Product Change Notice (PCN)

PCN Number: PCN-0374184R-01

Product(s) Affected:
CEP-1162

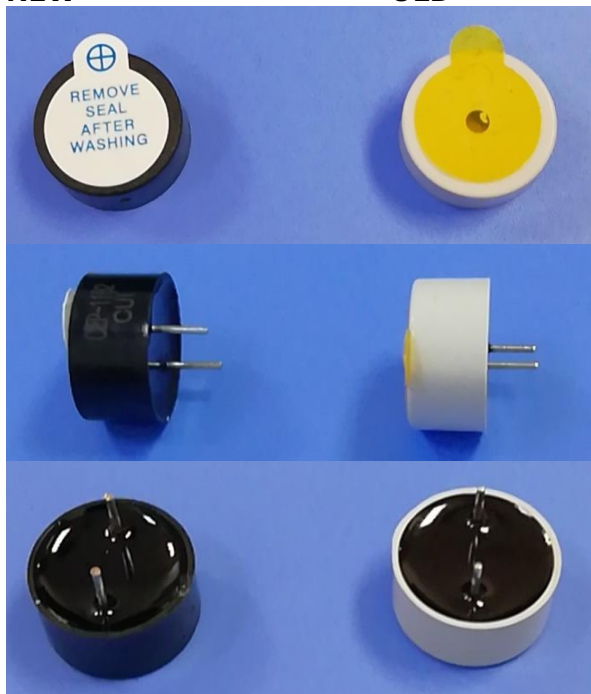
We are upgrading the plastic housing from PBT to PBT+30% glass, and this is to achieve UL94V-0 Flame retardant level. This is a higher level than the original which was UL94V-1. The color will also be changing from grey to black.

- Plastic change from PBT to PBT +30% Glass
- Housing color from grey to black
- Db from 80 to 85
- Operating temp now -40 ~ 85 instead of -20 ~ 85
- Storage Temp now -40 ~ 90 instead of -30 ~ 90
